AEROPRAKT SERVICE BULLETIN

No. SB A32-07

REPLACEMENT OF THE NOSE WHEEL FORK HINGE BRACKET OF A32 AND A32L AIRCRAFT

Photo 12

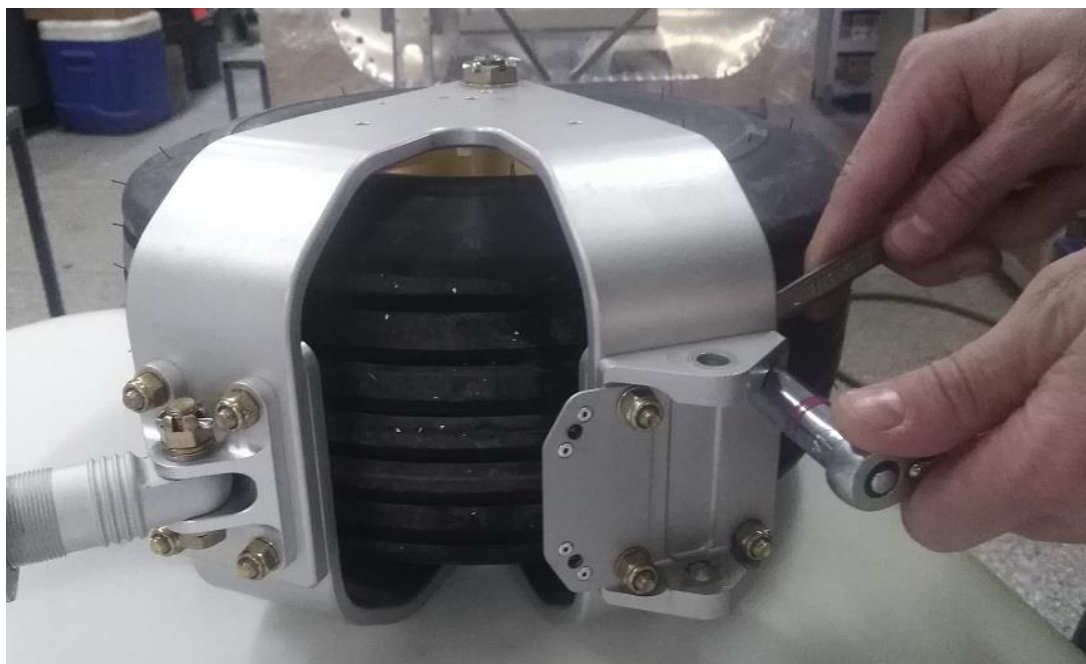
3.11) Undo the nuts attaching the bracket to the wheel fork (Photo 12).

Photo 14

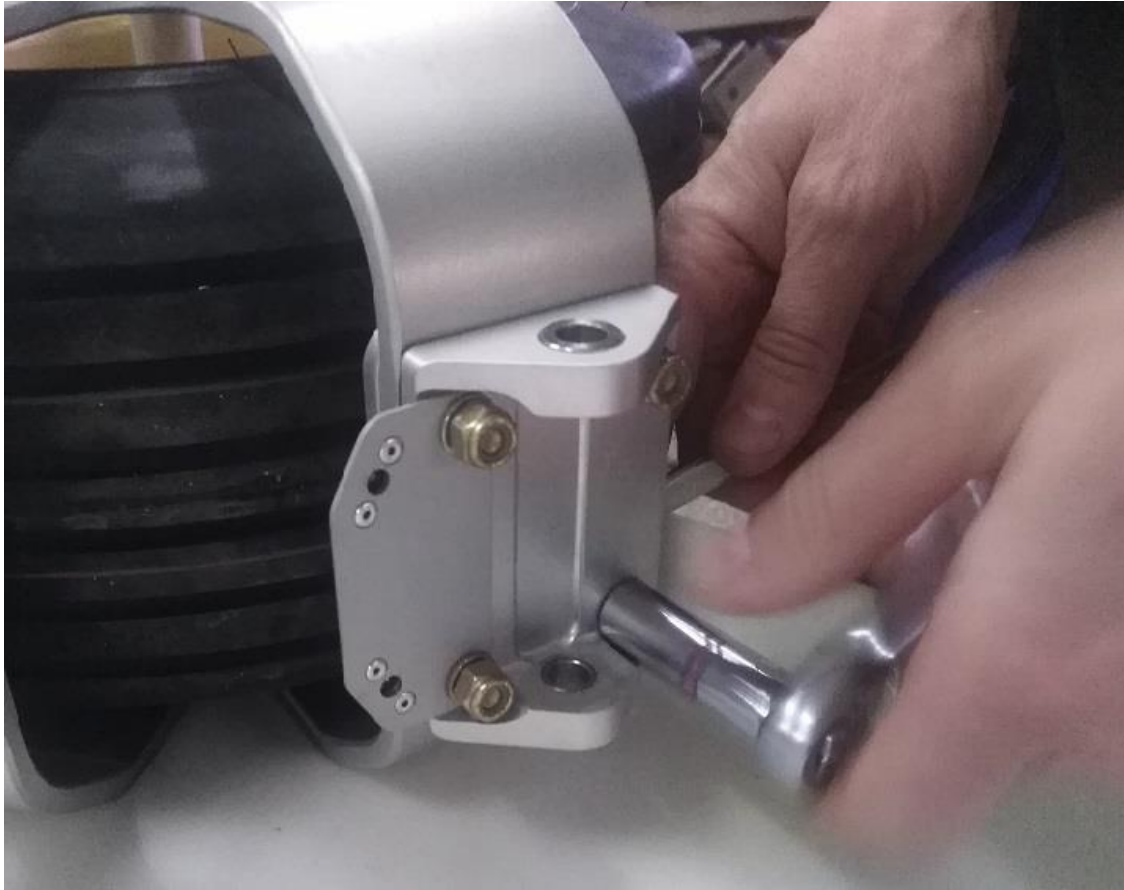
3.13) Install the new bracket and tighten the nuts (Photo 14).
